## MEMORANDUM

RE: **Site Source Control (SSC) Work Plan Addendum No. 7  
Proposed Termination of the SSC Sampling Program  
GM Powertrain Bedford Facility  
Bedford, Indiana**

**SEEPS/SPRINGS WITH NON DETECT RESULTS FOR FOUR CONSECUTIVE EVENTS**  
 SSC WORK PLAN ADDENDUM NO. 7  
**GM POWERTRAIN BEDFORD FACILITY**  
*Bedford, Indiana*

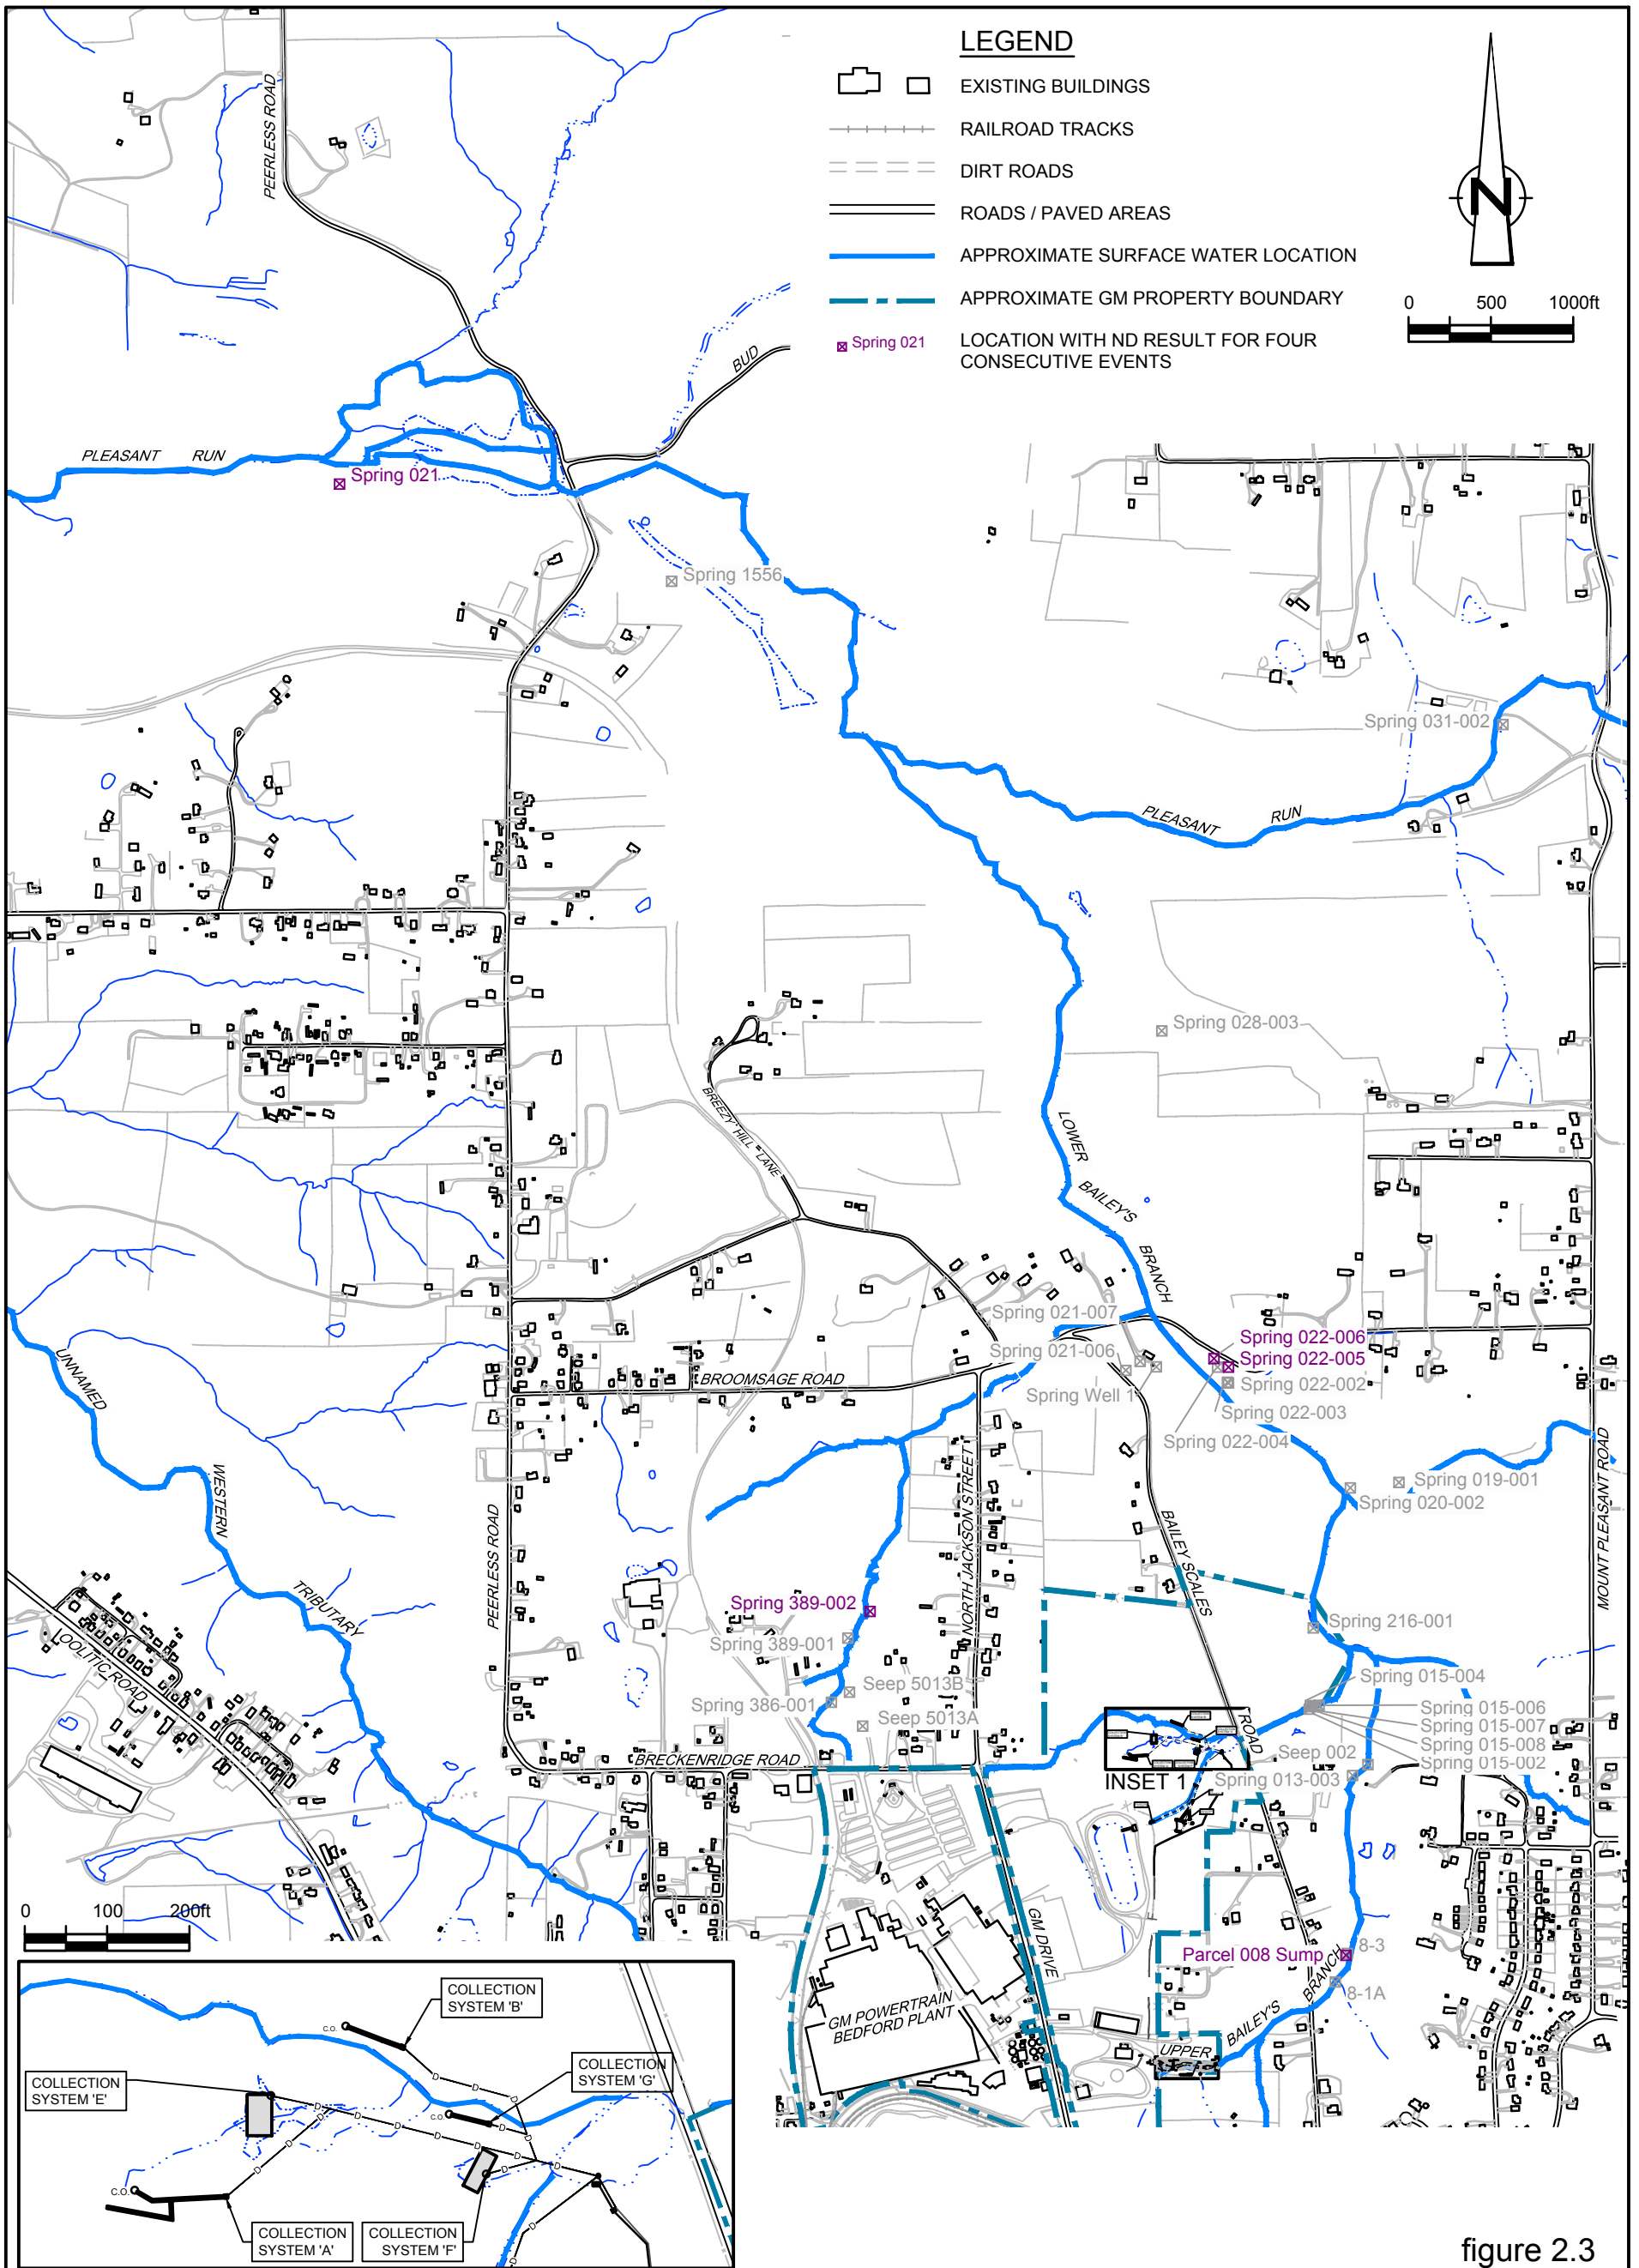
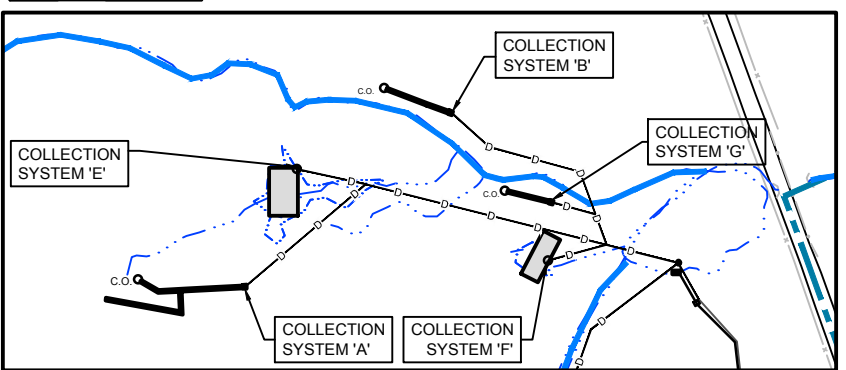
The following five seep and spring locations have not exhibited detectable concentrations of PCBs through a minimum of four consecutive events of either high-flow or low-flow sampling. Therefore, the following locations are proposed to be removed from the Monitoring Program:

- Parcel 008 Sump
- Spring 021
- Spring 022-005
- Spring 022-006
- Spring 389-002

Figure 2.3 presents the location of seeps/spring with non detect results for four consecutive events.

figure 2.4  
**SEEPS/SPRINGS DRY FOR MULTIPLE EVENTS**  
**SSC WORK PLAN ADDENDUM NO. 7**  
**GM POWERTRAIN BEDFORD FACILITY**  
*Bedford, Indiana*

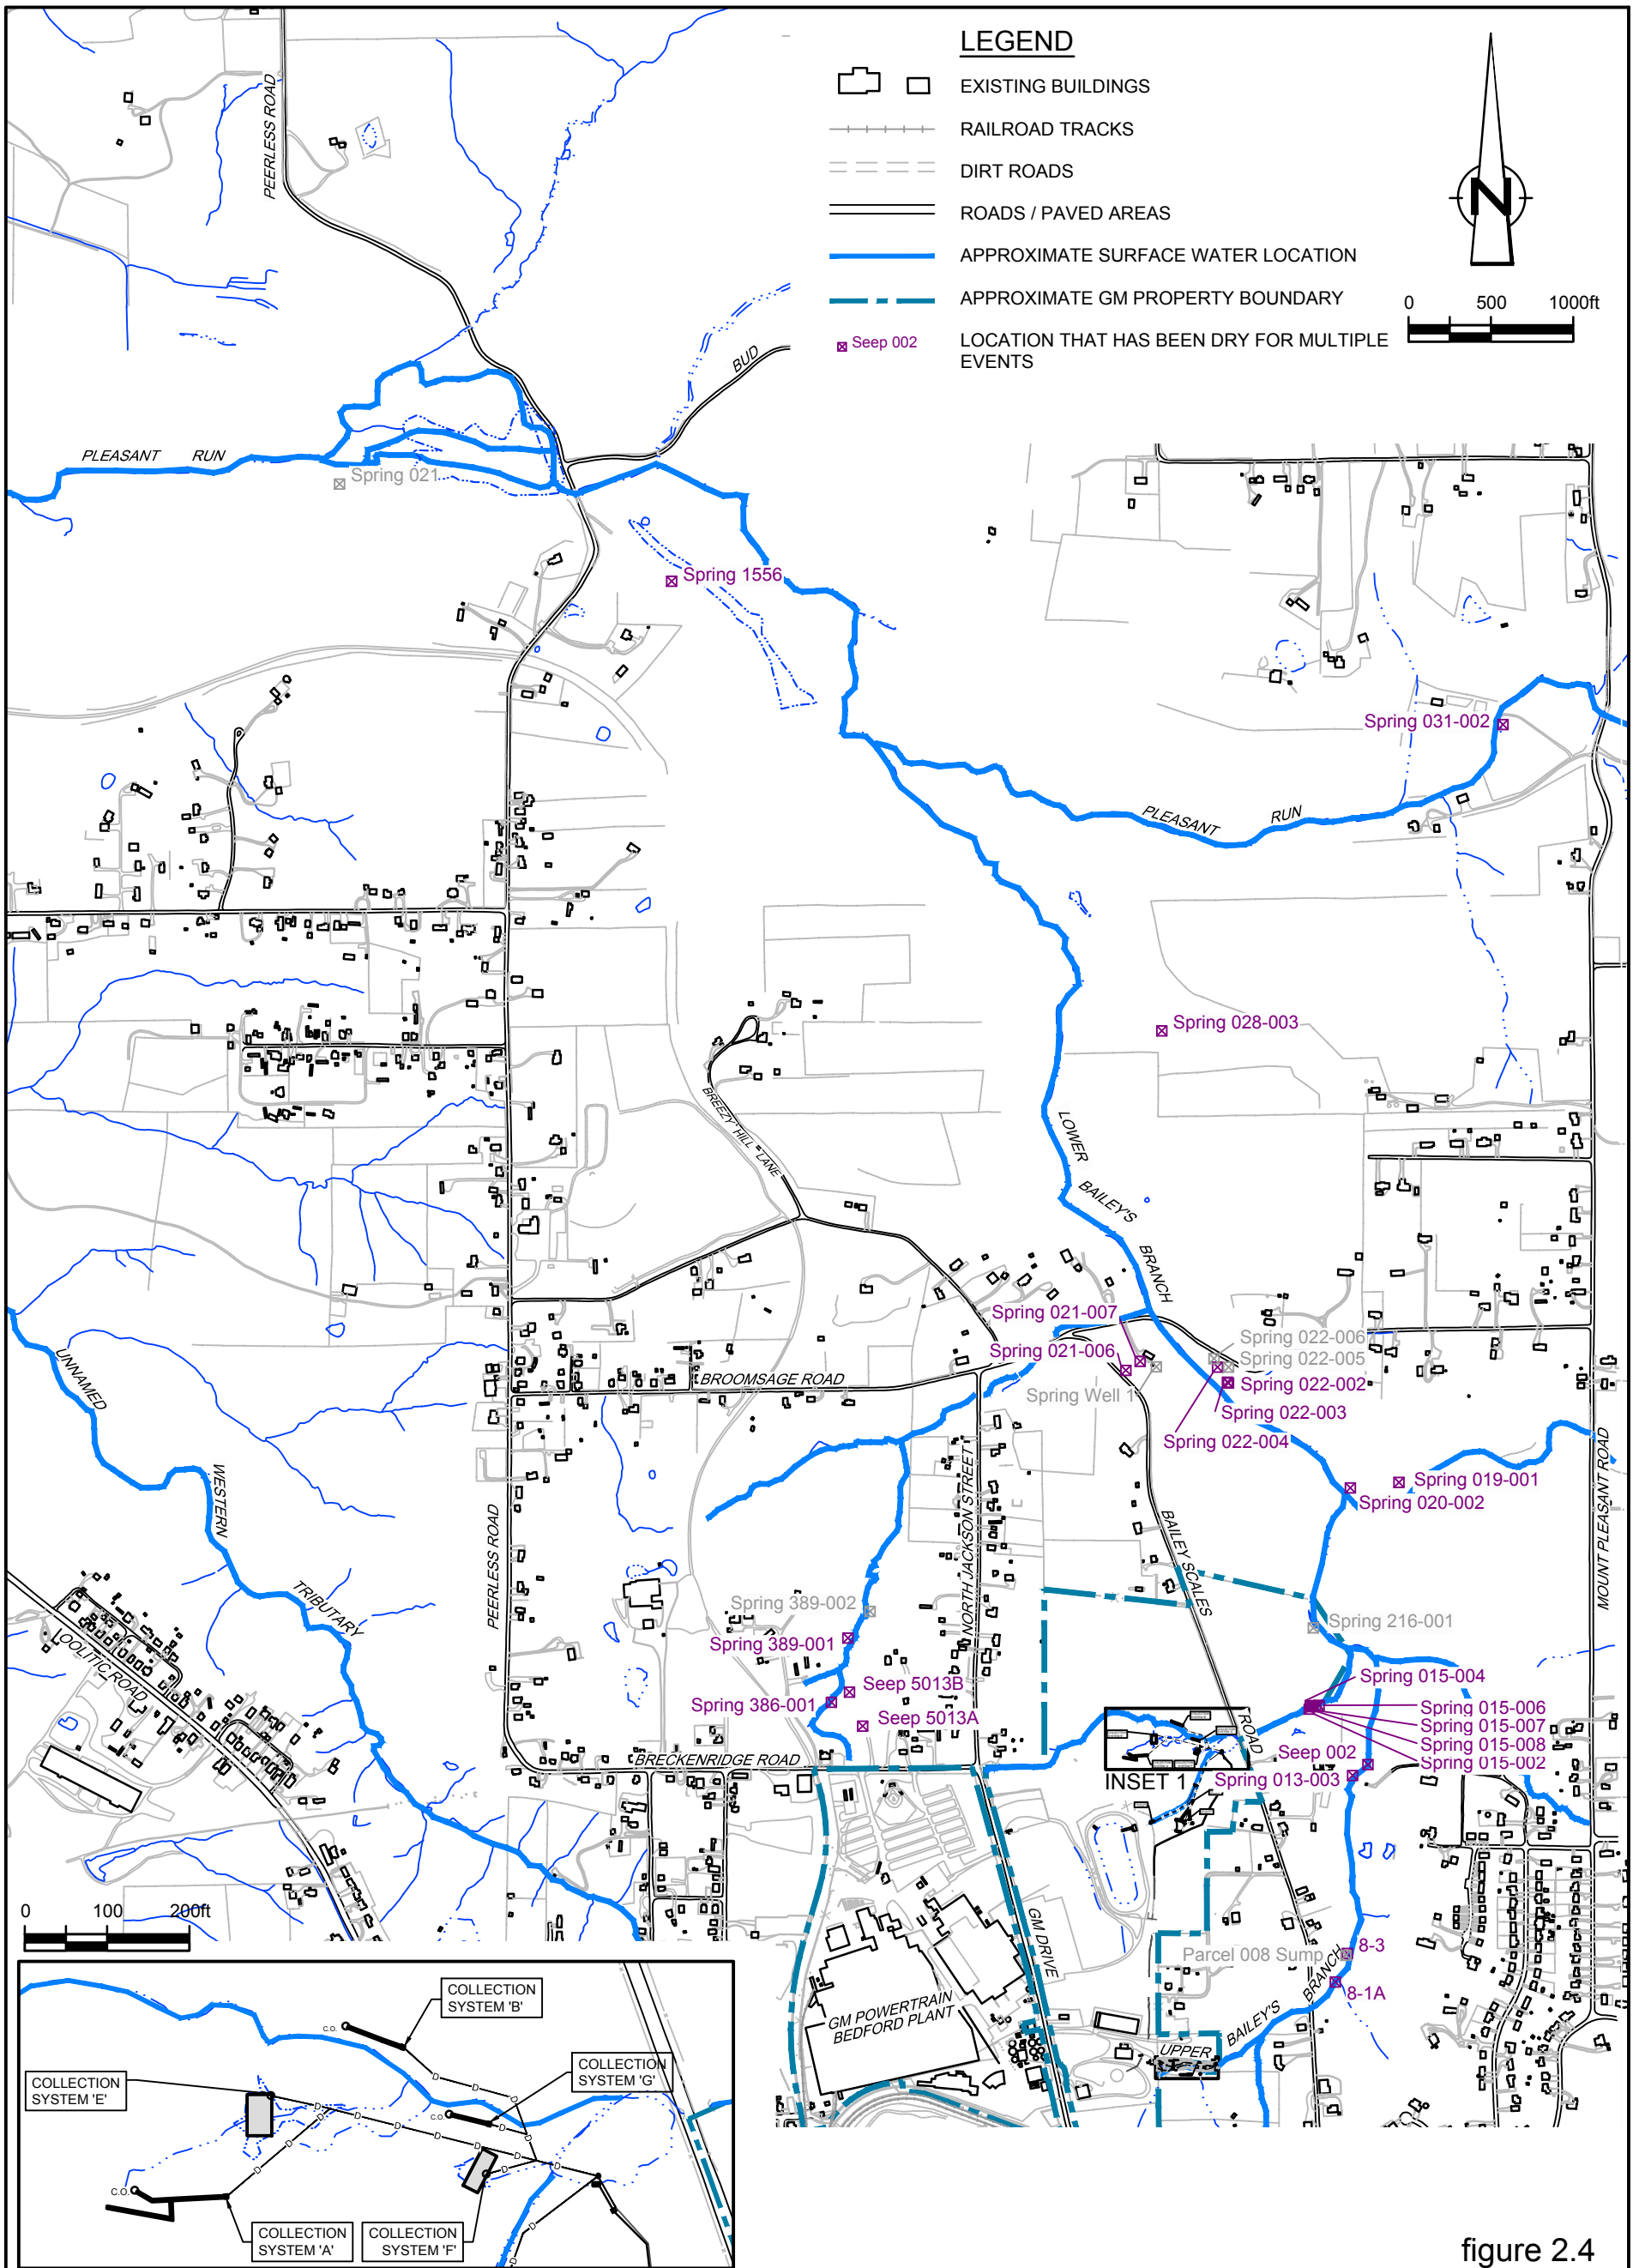
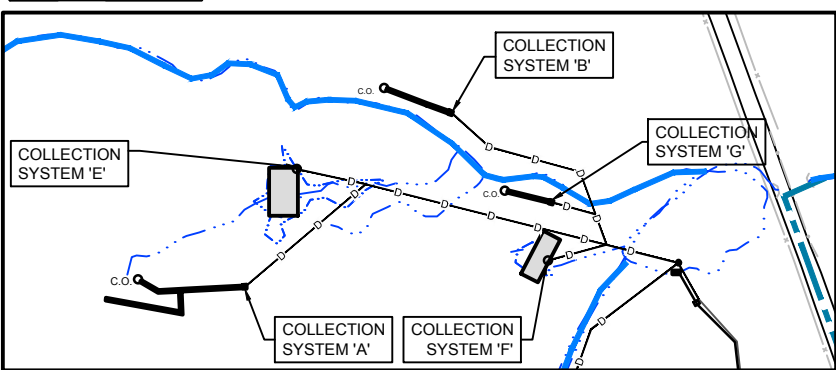
The following 23 seep and spring locations have been dry multiple times and are proposed to be removed from the Monitoring Program:

- 8-1A
- 8-3
- Seep 002
- Seep 5013A
- Seep 5013B
- Spring 013-003
- Spring 015-002
- Spring 015-004
- Spring 015-006
- Spring 015-007
- Spring 015-008
- Spring 019-001
- Spring 020-002
- Spring 021-006
- Spring 021-007
- Spring 022-002
- Spring 022-003
- Spring 022-004

- Spring 028-003
- Spring 031-002
- Spring 386-001
- Spring 389-001
- Spring 1556

Figure 2.4 presents the location of seeps/springs that were dry for multiple events.
